Nancy Tran Land Use Board Secretary Borough of Highlands Land Use Board 151 Navesink Avenue Highlands, New Jersey 07732

Re: Completeness Review No. 1 Applicants: Edward and Lori Pahler Block 54, Lot 13 35 Miller Street Borough of Highlands, Monmouth County, New Jersey Our File No.: HLPB25-09

The Applicant seeks to construct a 2 $\frac{1}{2}$ story single-family dwelling on an existing vacant lot on which a multifamily dwelling recently stood. The proposed residential building will consist of three (3) bedrooms with site improvements and 3 parking spaces (garage under (2) and driveway).

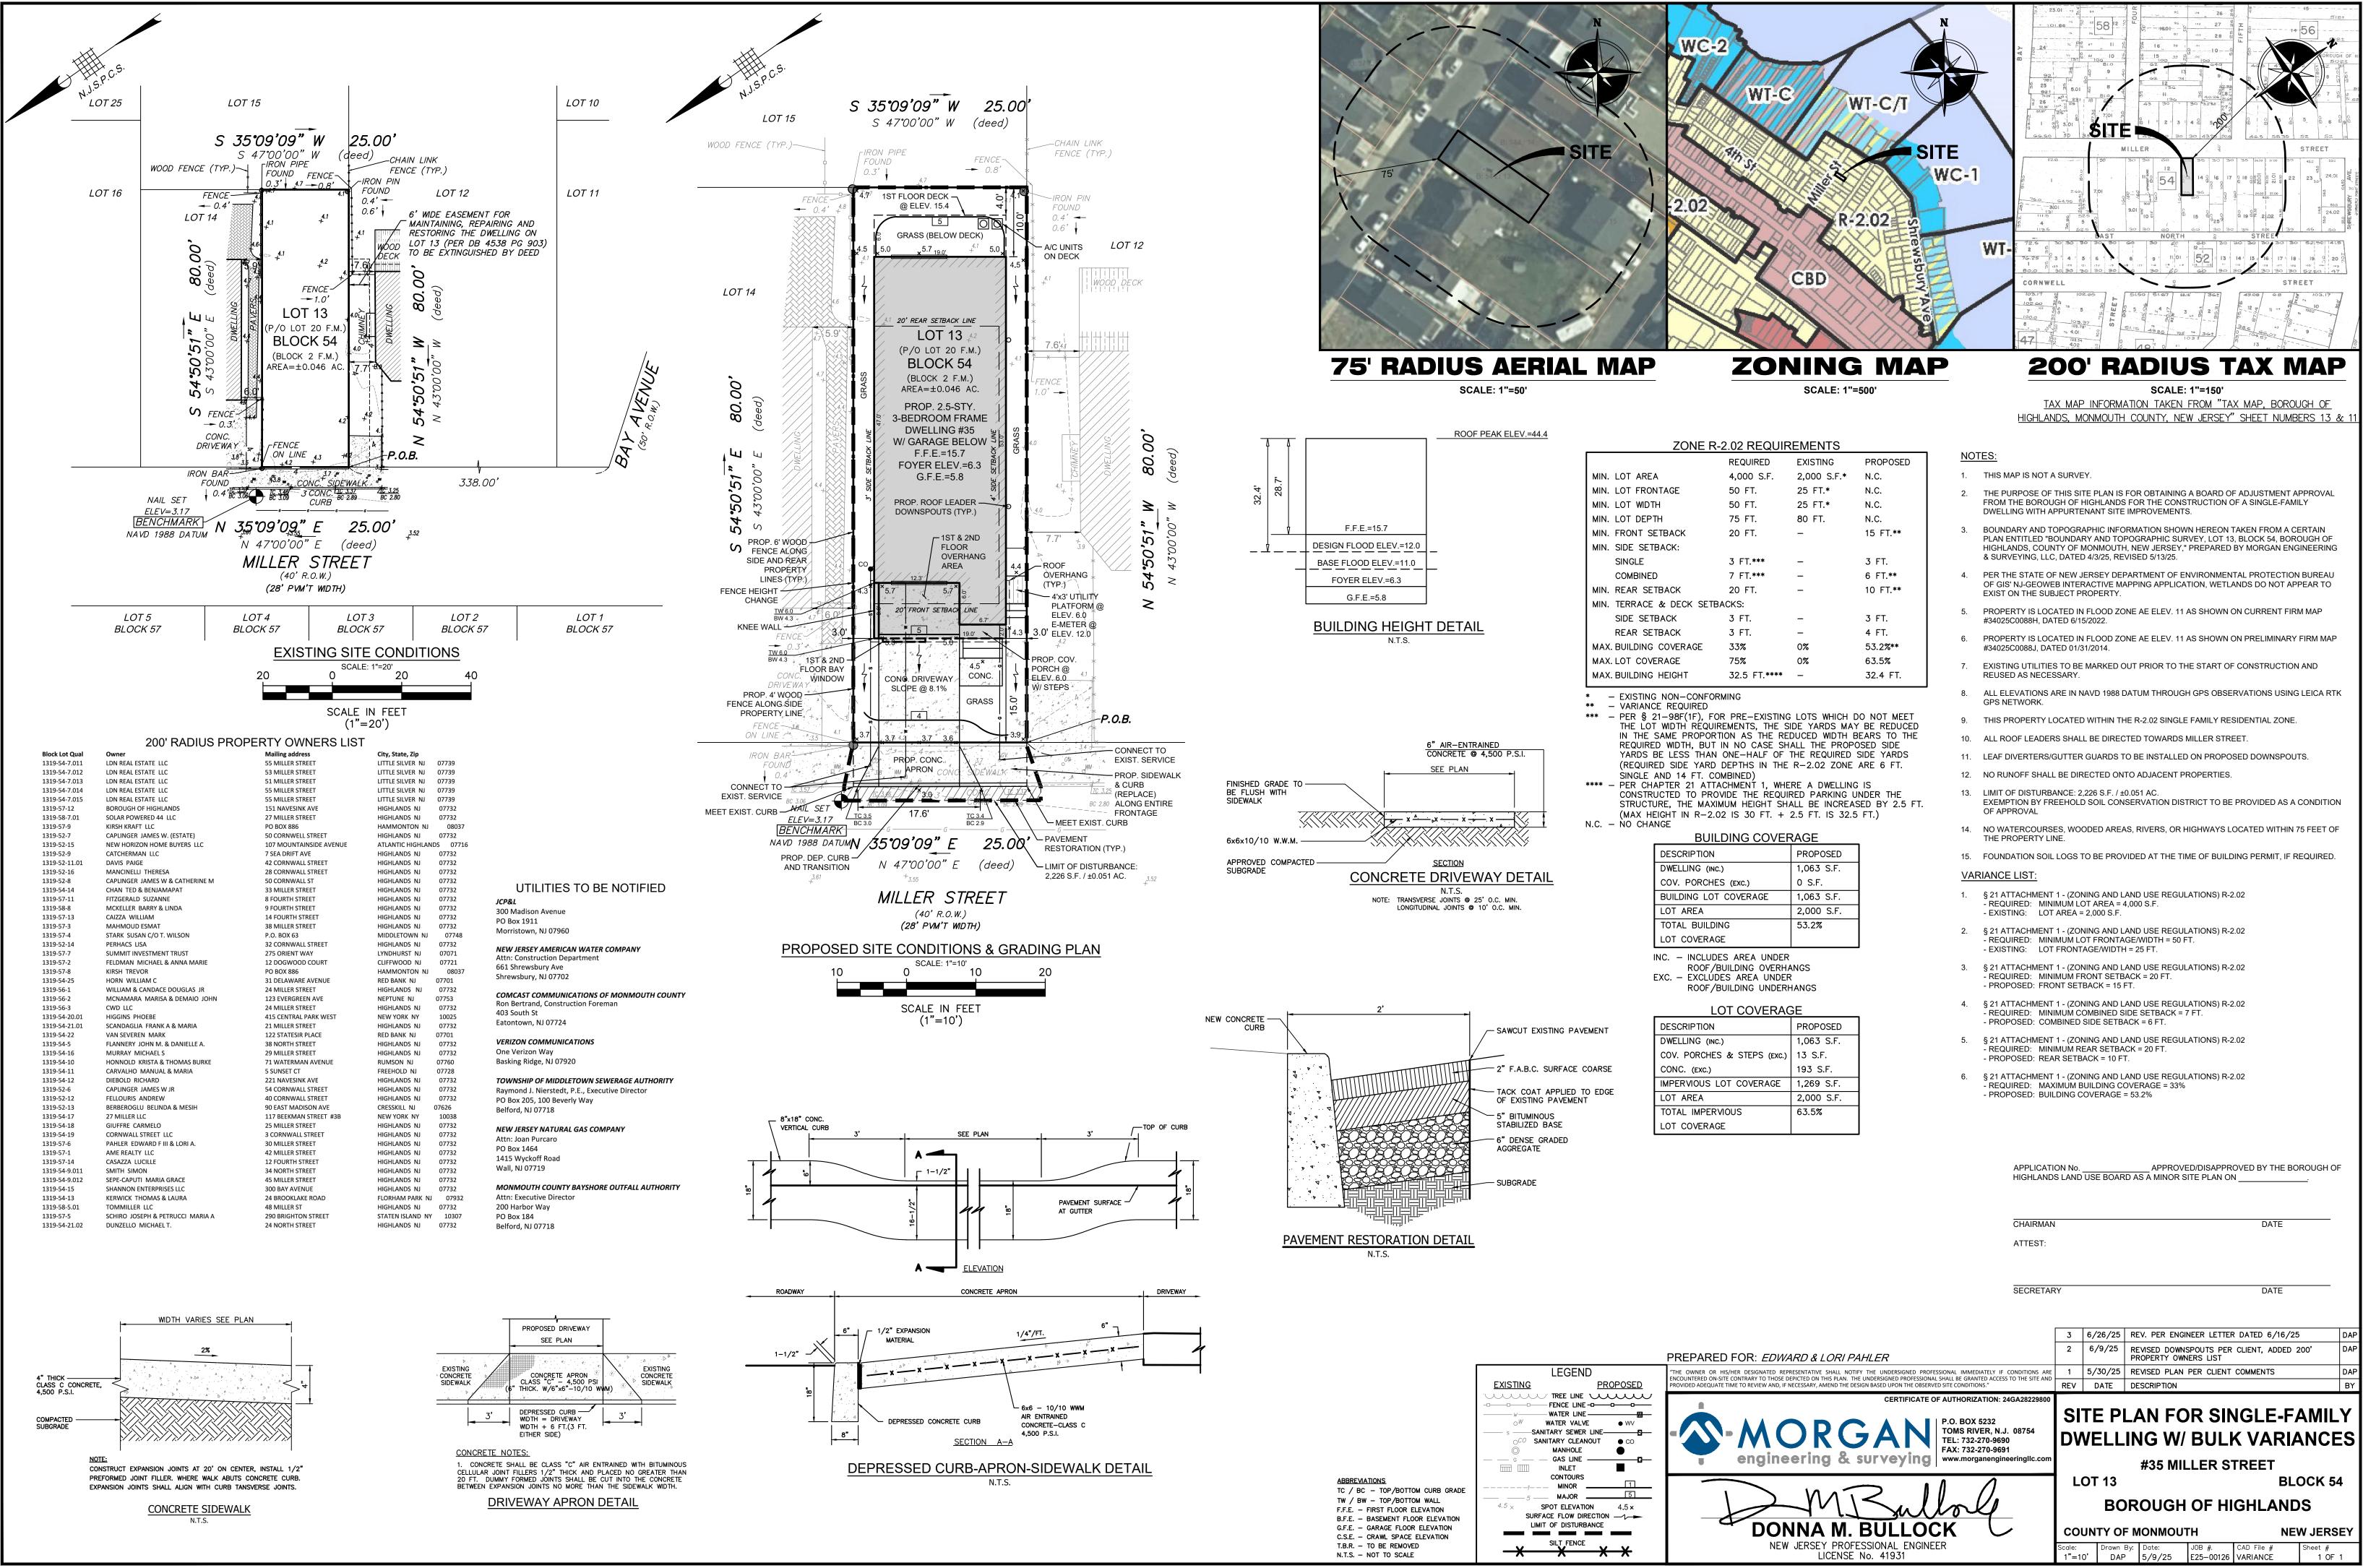
7. It appears that the front yard setback may not be in conformance with the prevailing setback. The lots closest to this property appear to meet the requirement, however the same determination cannot be made about the nearby newer built dwellings.

Please analyze the front setback as a prevailing setback according to § 21-79.B.

- 8. Please update the lot coverage table to show covered porches and steps, and concrete, as included items. The total percentage of lot coverage is shown correctly.
- 9. There is an existing 6 ft wide by 60 ft long easement on Lot 12 along the common line with the property. The easement is described in Deed Book 4538 Page 903 (yr. 1985) as "for the purpose of maintaining, repairing and restoring the dwelling erected upon Lot 13. This easement being necessitated because the side yards on Lot 13 are only six inches on one side and one ft. eleven inches on the other...."

- 10. Indicate whether the lot surfaces will be grass, gravel and/or landscaped.
- 11. The right rear and side yard proposed elevations are directing runoff to Lot 12. Please redirect the runoff to the street.
